**CITY OF GAINESVILLE PLANNING DIVISION  
SUMMARY OF COMMENTS**

<b>Petition Number</b> 7SUB-02 DB	<b>Development Review Board</b>
<b>Review Date</b> 5/09/02	<b>Reviewed By</b> Carolyn R. Morgan
<b>Project Name/Description</b>	Blues Creek Subdivision Unit 6-H

Petition No. 7SUB-02DB	Date Plan Rec'd: 4/30/02	Review Type: Stage II Preliminary Plat and Plan Review (Design Plat)
Review For: Technical Review Committee    Review Date: 5/09/02		 Project Planner: Carolyn Morgan

TYPICAL ROAD CROSS SECTION

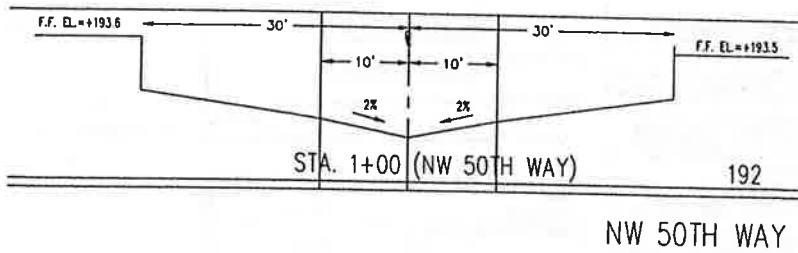
**Real Estate** Utility plans need to indicate a typical street cross section showing the space allocations of utilities - electric, water, sewer, gas, cable TV and telephone. Easements can not be finalized until after the GRU plan review.

C-1B

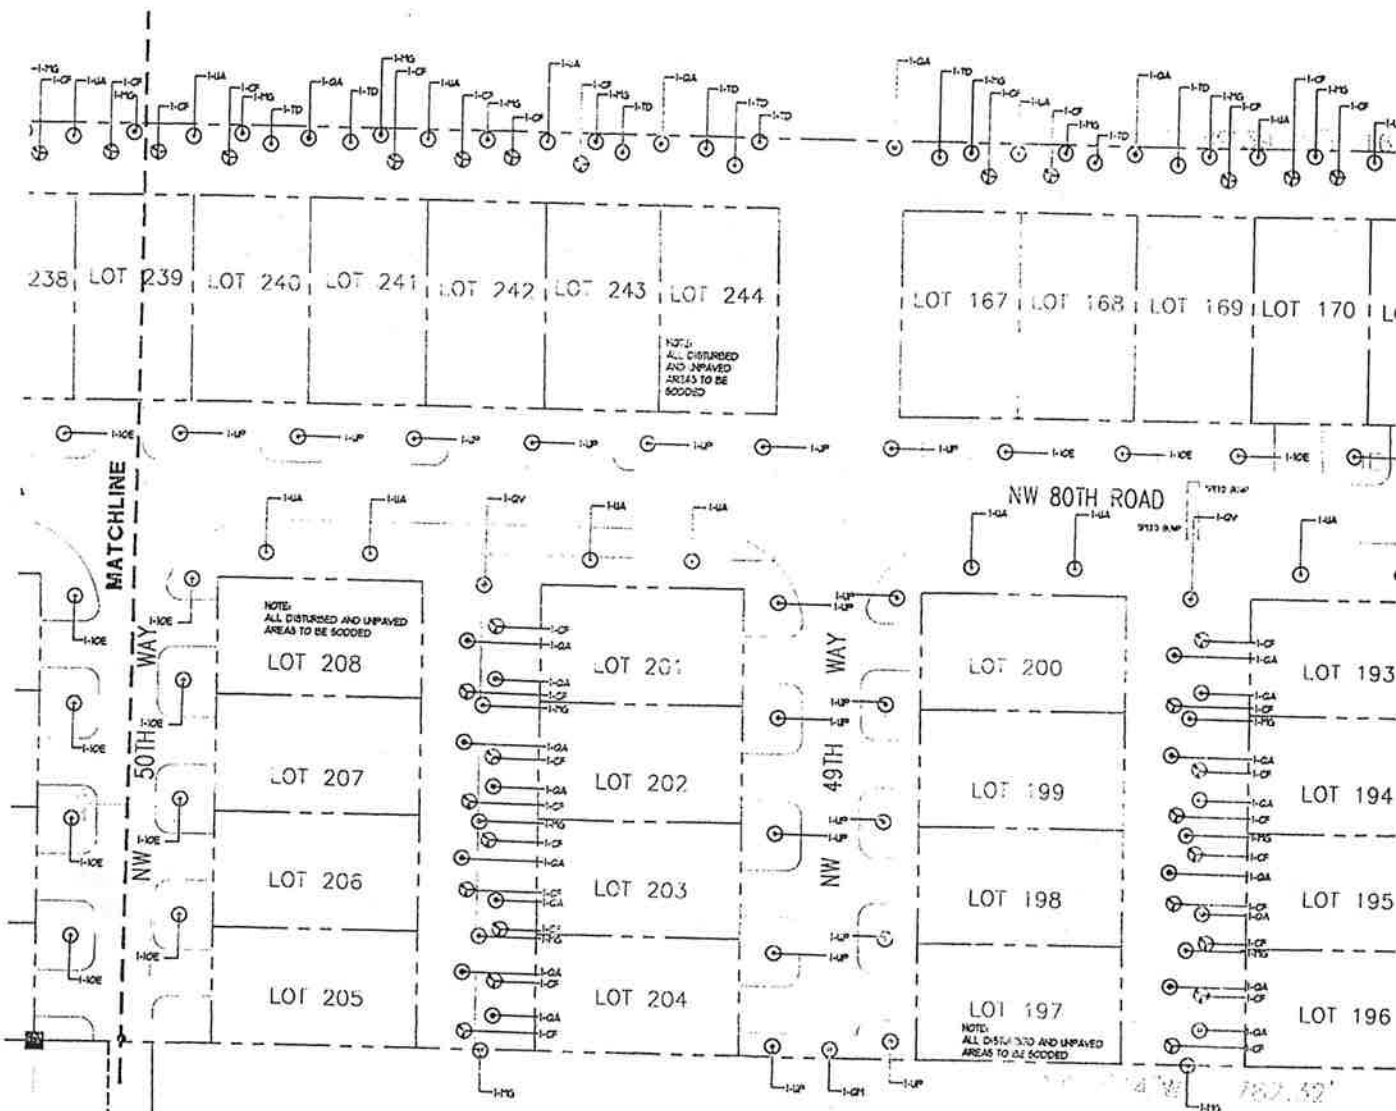
Concern: The areas labeled on the plans submitted and commented on last month identified "dense vegetation screen" areas. These now are shown as disturbed areas to be sodded with a few trees planted. The owner, agent, and I had discussed maintaining these areas in as natural a state as possible, keeping a barricade around them as much as possible during the construction so that the soil is not compacted. The agreement, I thought, was to remove "dense" from the Design Plat and identify it as a "vegetated area." Preserving as much of the original vegetation as possible in these areas and replanting with native understory shrubs rather than sodding will create an areas easier to maintain and more supportive of wildlife.

- Put the 11 regulated trees to be preserved on the site plan C-1 (not the site plan showing trees. C-1B).
- Show tree barricades drawn to scale around the trees to be preserved.
- Show barricades around the areas that were labeled as "dense vegetated screen" to keep the soil from getting compacted during construction. The barricades can be removed to work in the area and then can be put back up. This method of working will maintain a friable soil appropriate for supporting vegetation.
- Add the comment to the General Notes:  
 "Trees will be preserved on site whenever possible. See the specifications for tree barricades on page \_\_\_\_\_. Before beginning any site work, the tree barricades must be inspected and approved by the Parks Division (334-2171)."
- Put the barricade information alluded to in the preceding comment on the appropriate
